**3 Volt Intel[®] Advanced Boot
Block Flash Memory
28F004/400/008/800/
016/160/320/640B3 (x8/x16)**

Specification Update

April 2002

Order Number: 297948-012

2. Invalid Read Durations for CE# High Pulse Width

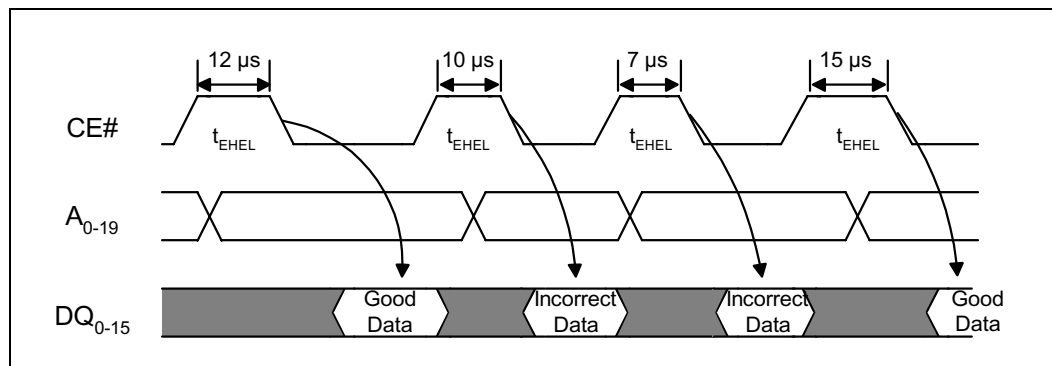
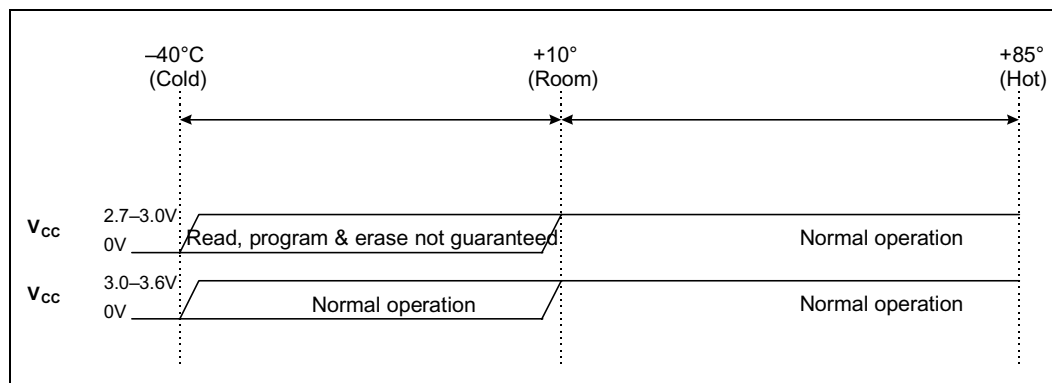
Problem: During consecutive read operations, CE# may be left low or toggled as desired. If CE# is toggled high (see diagram below) for 4 μs –11 μs between read operations, subsequent reads will return incorrect data.

Implication: If CE# is not toggled between consecutive reads, there is no impact. Any application that toggles CE# between read operations will be affected if the CE# high pulse width is within the nonfunctional range, i.e., 4 μs \leq t_{EHEL} \leq 11 μs .

Workaround: Either of the following actions will prevent this erratum:

1. Do not toggle CE# between consecutive read operations
2. Insure t_{EHEL} is less than 4 μs or greater than 11 μs

5. Maximum I_{CCD} Change

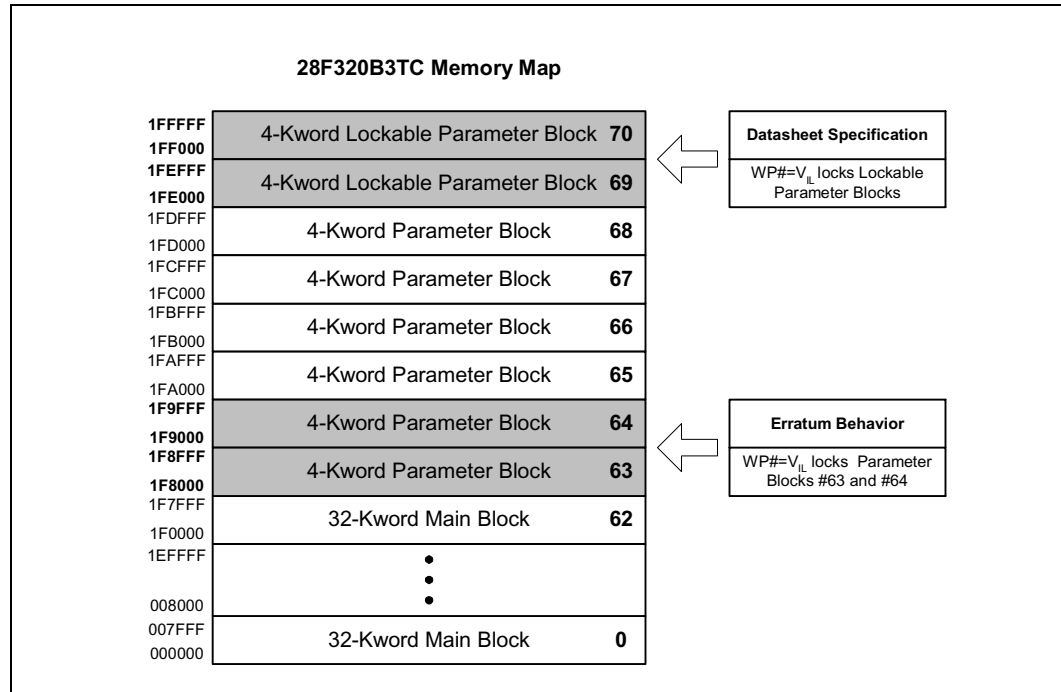
Problem: The maximum I_{CCD} increases from 20 μ A to 25 μ A. The following in the revised I_{CCD} specification:

Implication: The maximum I_{CCD} is specified under worst case conditions only ($V_{CC} = 3.6$ V, temperature = +85 °C). The typical I_{CCD} specification should be used to determine I_{CCD} current draw under typical conditions ($V_{CC} = 3.3$ V, temperature = +25 °C). The typical I_{CCD} specification has not changed.

6. 28F320B3TC Block Locking Failure

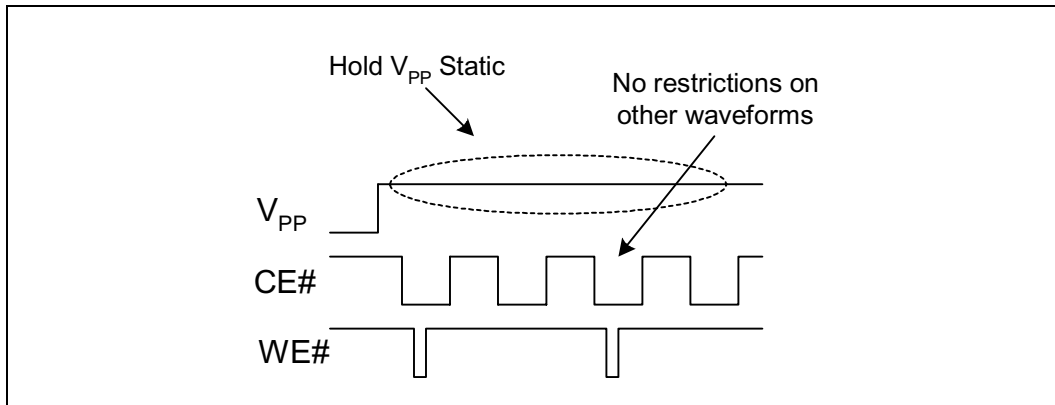
Problem: For the 0.18 μ m 32 M-bit top boot devices affected by this erratum, block locking functionality deviates from the datasheet specification. WP#=V_{IL} protects blocks #63 and #64, instead of blocks #69 and #70).

- 1) The two Lockable Parameter Blocks (blocks #69 and #70) are not protected when WP#=V_{IL}; and
- 2) When WP#=V_{IL}, blocks #63 and #64 will be locked, and any attempts to program or erase these two blocks may fail.

- 1) Set WP#=V_{IH} when programming or erasing blocks #63 and #64. In addition, hold V_{PP}≤V_{PPLK} when not programming or erasing for additional protection against accidental writes; and
- 2) Temporarily, have software swap the contents of blocks #63 and #64 with the contents of blocks #69 and #70. If code was originally in blocks #69 and #70, utilize jump routine to blocks #63 and #64.

7. 28F320B3xC Reset Failure

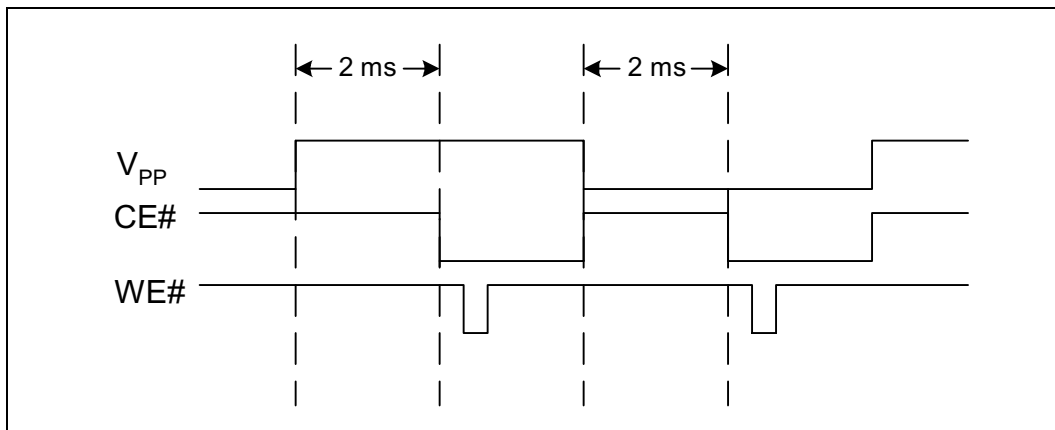
Problem: The 0.18 μ m 28F320B3xC devices can unintentionally reset under certain conditions where V_{PP} toggles.

Implication: When the reset occurs, any command being executed is interrupted and the flash switches to read array mode.

- 1) Tie V_{PP} to V_{CC}
- 2) If the third and fourth digits on the top side FPO mark (third line) are equal or greater than “23”, then V_{CC} may be set from 2.7 V to 3.3 V. V_{CC} must not exceed 3.3 V.
- 3) Set V_{PP} to a static high or static low level as shown here; and

- 4) Wait 2 ms after a V_{PP} transition to access the flash device as shown here.

Figure 1. Workaround Placement

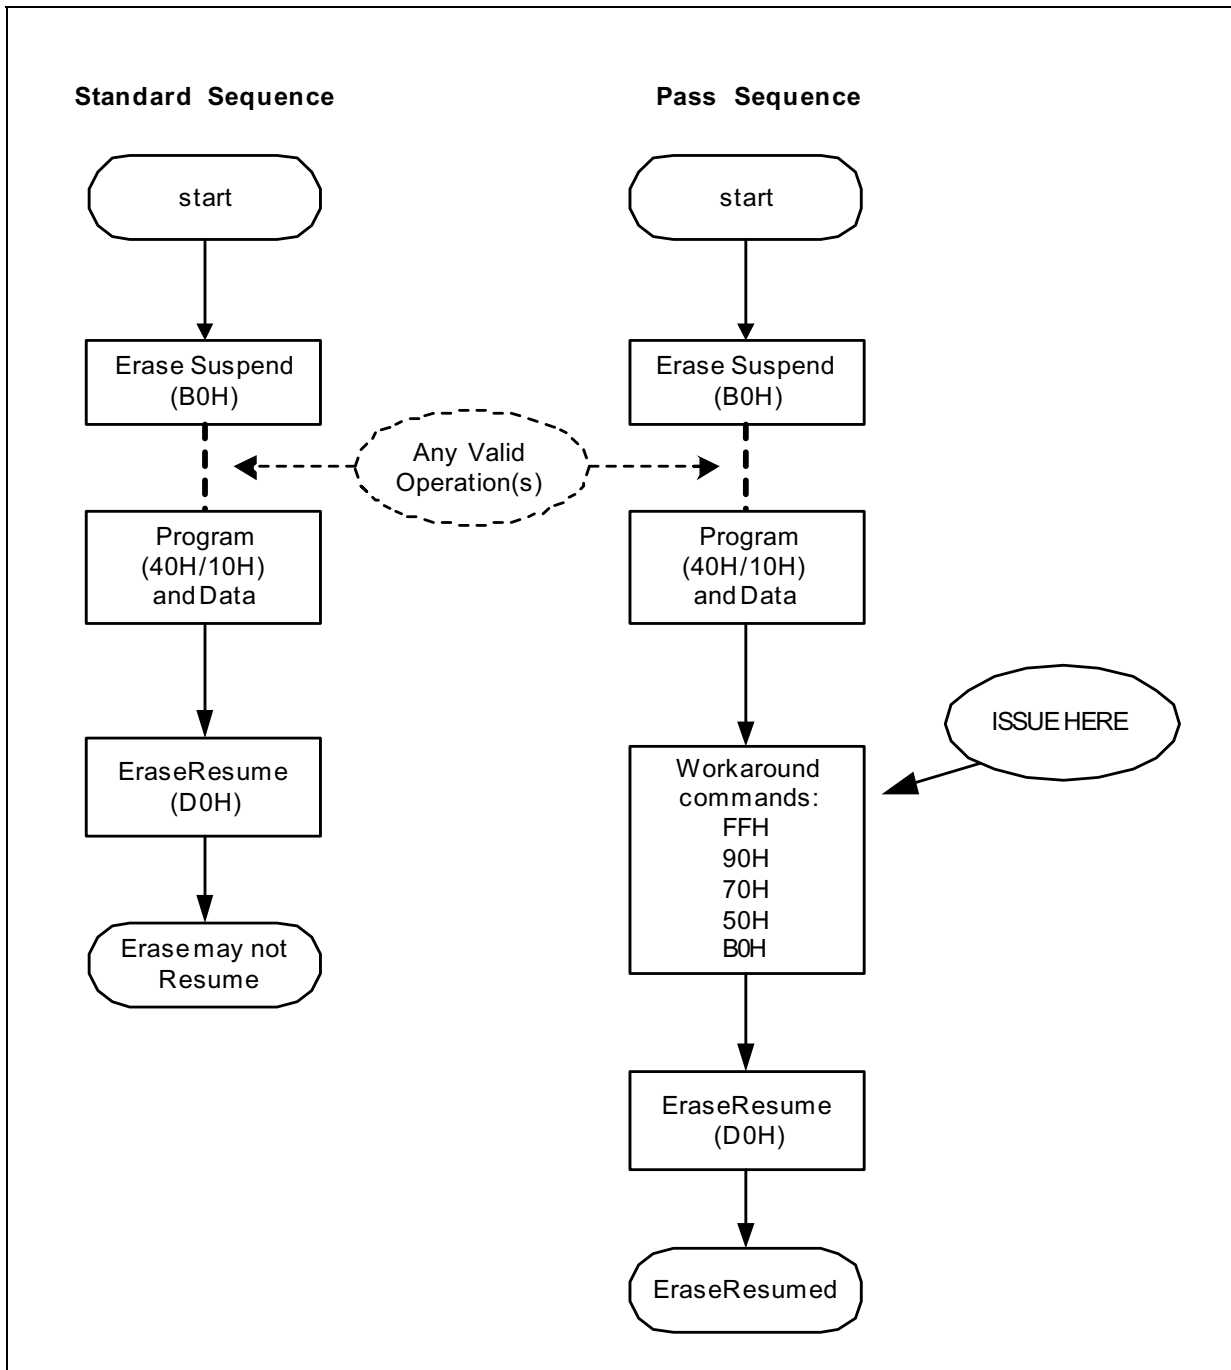
Problem: On the 0.18µm 28F160B3xC device, a design anomaly was discovered. During an Erase-Suspend operation, if the Program (40H/10H) sequence is executed, under limited conditions the proceeding Erase Resume command (D0H) may not actually resume the device. No customers have reported failures in product applications. Customers who use any version of FDI (Intel Flash Data Integrator) software will not see this issue. If the Read Array command is issued prior to the Erase Resume command, users will not see the issue (typical in XIP applications).

Implication: The Resume Command (D0H) may be ignored by the device and will not correctly resume. The device will appear to remain in suspend (via status register). After a reset of the flash device the status register will clear. This failure has been recreated in a lab environment only.

1. If FDI (Intel Flash Data Integrator) software is used, users will not see the issue.
2. During an Erase-Suspend (B0H), user must issue any of the following commands listed in Table-1 after issuing the Program (40H/10H) and data sequence but before issuing the Erase-Resume (D0H) command.
